UNITED STATES PATENT AND TRADEMARK OFFICE

APPLICATION NO.	FILING DATE	FIRST NAMED INVENTOR	ATTORNEY DOCKET NO.	CONFIRMATION NO.
10/803,392	03/18/2004	Christopher E. Banas	6006-146	5517

Office Action Summary

DETAILED ACTION

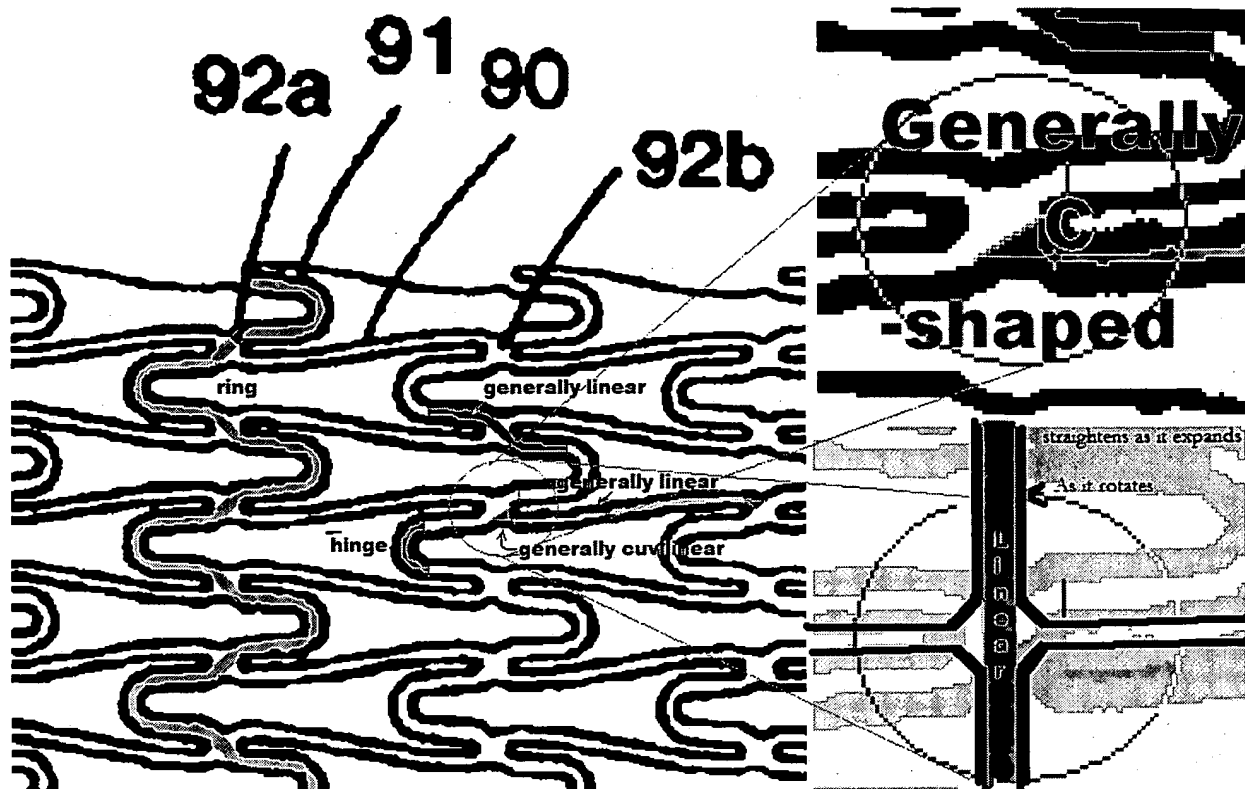
Though “strut, hinge, peak and valley” is not use to describe the ring, that is a semantic argument, so in the broadest reasonable interpretation of the claim the ring includes generally linear struts interconnected the peaks and valleys by hinge elements (see the figure below).

The struts are generally linear and become more linear with expansion (see the figure below).

The interconnecting elements edges of Wolinsky do have a generally curvilinear shape which is generally C-shaped (see the figure below).

The following figure should help illustrate the Examiners interpretation of the claims.
